Corporate Environmental Programs
General Electric Company
100 Woodlawn Avenue, Pittsfield, MA 01201

August 20, 2002

**Re: GE-Pittsfield/Housatonic River Site
Newell Street Area I (GEC440)
Revised Proposal for Supplemental Pre-Design Investigations**

**GENERAL ELECTRIC COMPANY
PITTSFIELD, MASSACHUSETTS
NEWELL STREET AREA I
REVISED SUPPLEMENTAL SAMPLING PROPOSAL
NON-PCB SOIL SAMPLE LOCATIONS
WITHIN 3- TO 6-FOOT
DEPTH INCREMENT**

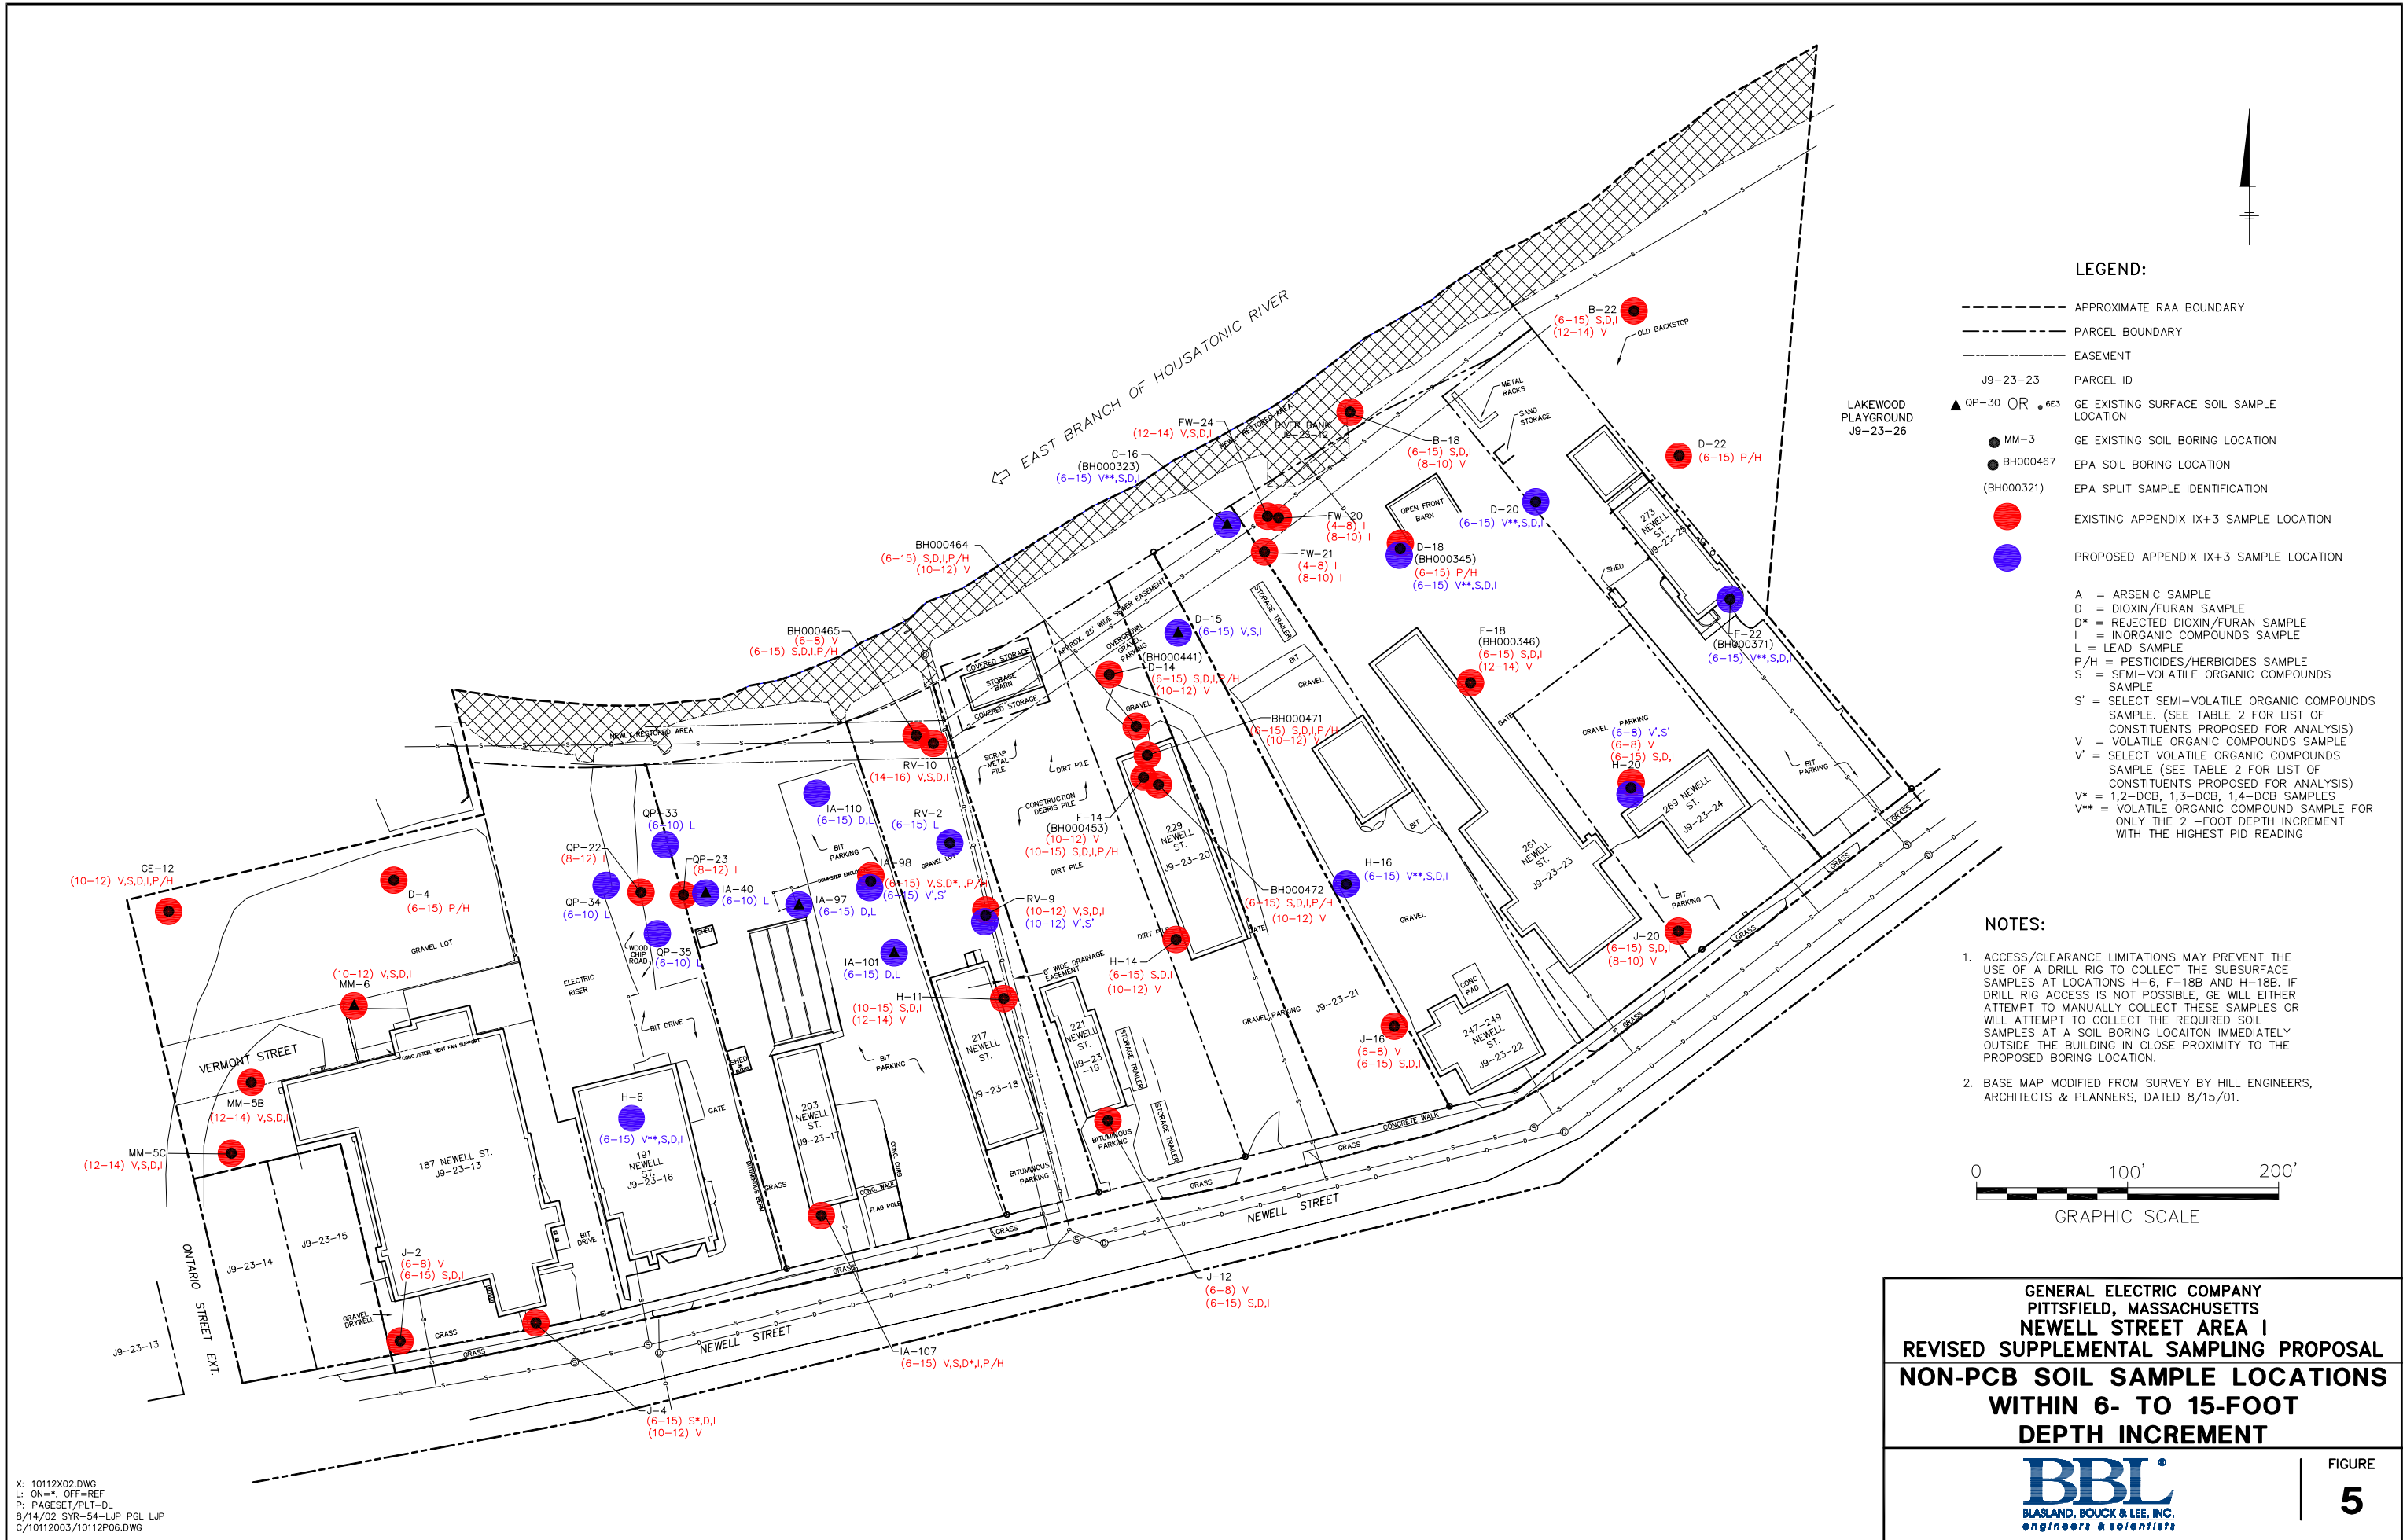
3- to 6-Foot Depth Increment: There are five prior samples (from four locations) that include this depth interval in which elevated lead concentrations were previously detected and which thus require horizontal delineation for lead in the 3- to 6-foot depth. These are the samples from locations QP-22 (4-8’), QP-23 (0-4’ & 4-8’), QP-27 (4-6’), and IA-98 (3-6’), as shown on Figure 4. To delineate the extent of elevated lead

concentrations in this depth increment, GE proposes to collect soil samples for lead analysis from the 3- to 6-foot depth increment at the following locations, as shown on Figure 4: QP-33, QP-34, QP-35, IA-40, IA-97, IA-101, IA-110, and RV-2.
